FINISH	HOT DIP GALVANIZED
CUSTOMER	FORESTSIDE ESTATES INC
PROJECT	66-95 ATTAMAR DRIVE (BLDG. C)
LOCATION	BRAMPTON, ONTARIO
DETAIL	EXTERIOR GALVANIZED EXHAUST SHAFT GRATING
DRAWN BY	BL
CHECKED BY	SCALE AS NOTED
DATE	MAY 19/2021
DRAWING NO.	21-000C-MS1

EXTERIOR GALVANIZED AIRSHAFT GRATING FOR BUILDING 'A'

FINISH	HOT DIP GALVANIZED		
CUSTOMER	FORESTSIDE ESTATES INC		
PROJECT	GG-95 ATTMAR DRIVE (BLDG. A)		
LOCATION	BRAMPTON, ONTARIO		
DETAIL	EXTERIOR GALVANIZED AIR SHAFT GRATING		
DRAWN BY	BL	CHECKED BY	DRAWING NO.
DATE	MAY 19/2021	SCALE	A5 NOTED
			21-000A-M51

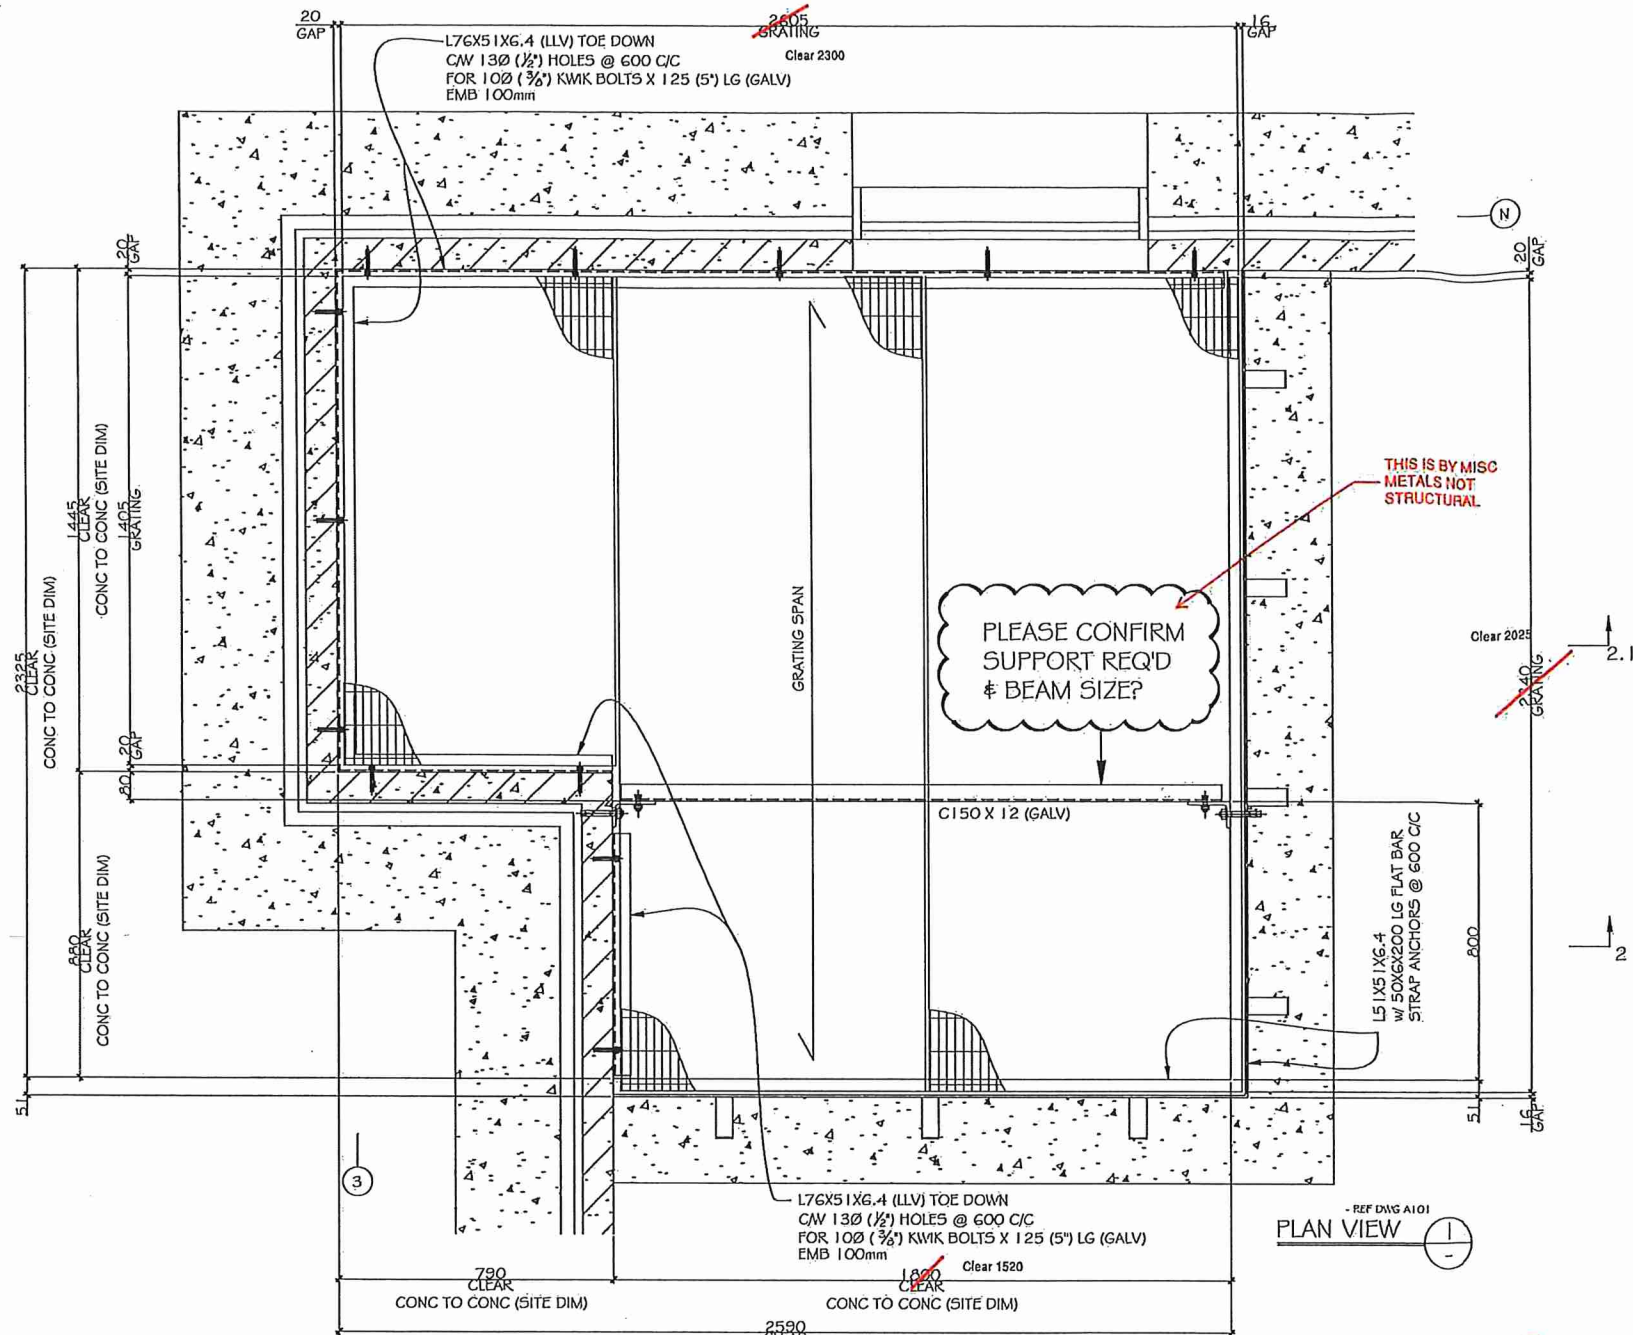
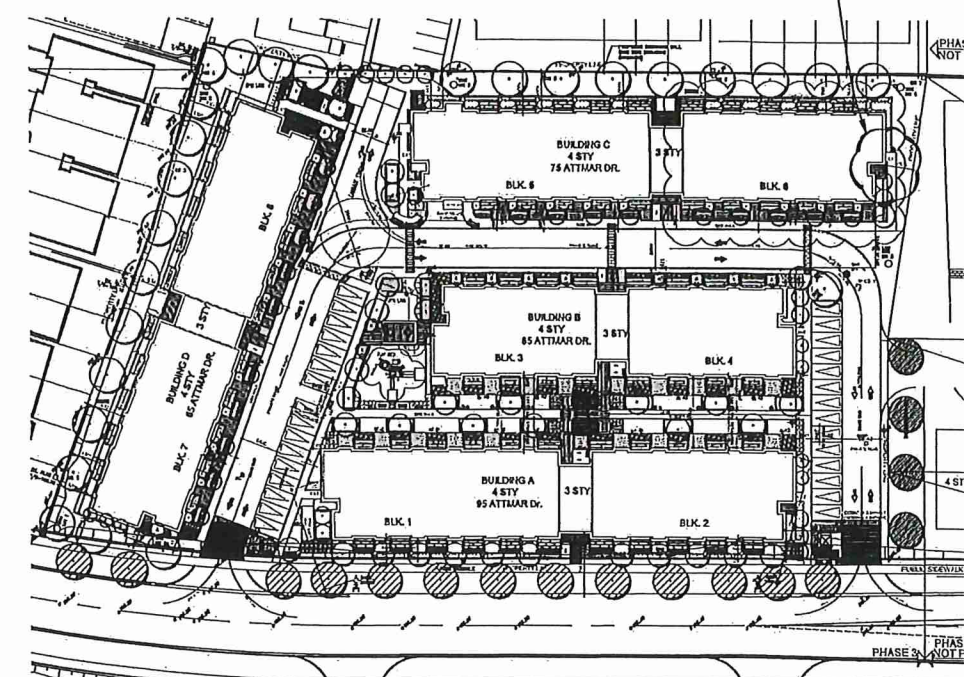
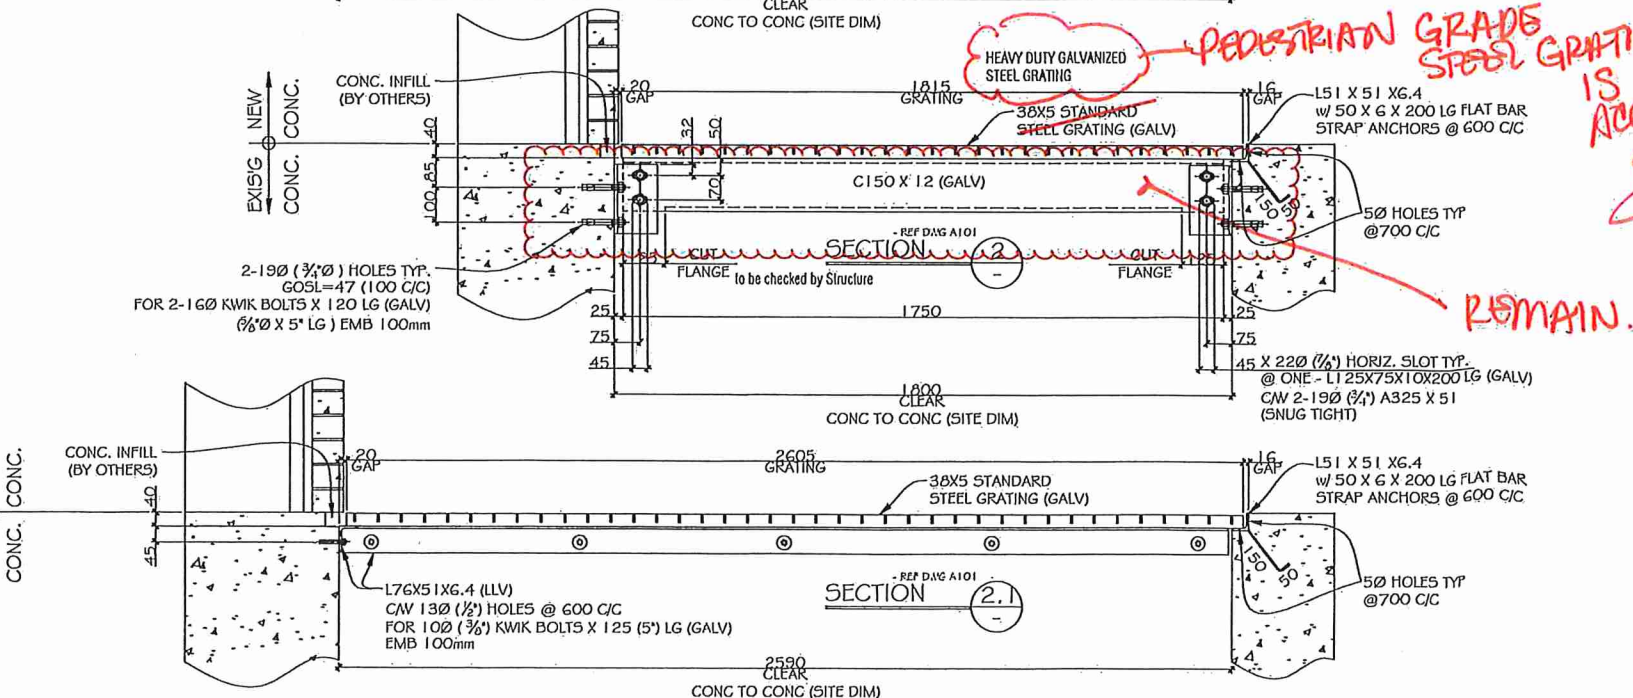
PROVIDE PENG STAMP

GRATING AND SUPPORT NEEDS TO BE DESIGNED FOR HEAVY TRUCK LOADING

THIS IS BY MISC METALS NOT STRUCTURAL

G+C: all beams dimensions must be checked by Structure, in terms of size and load.
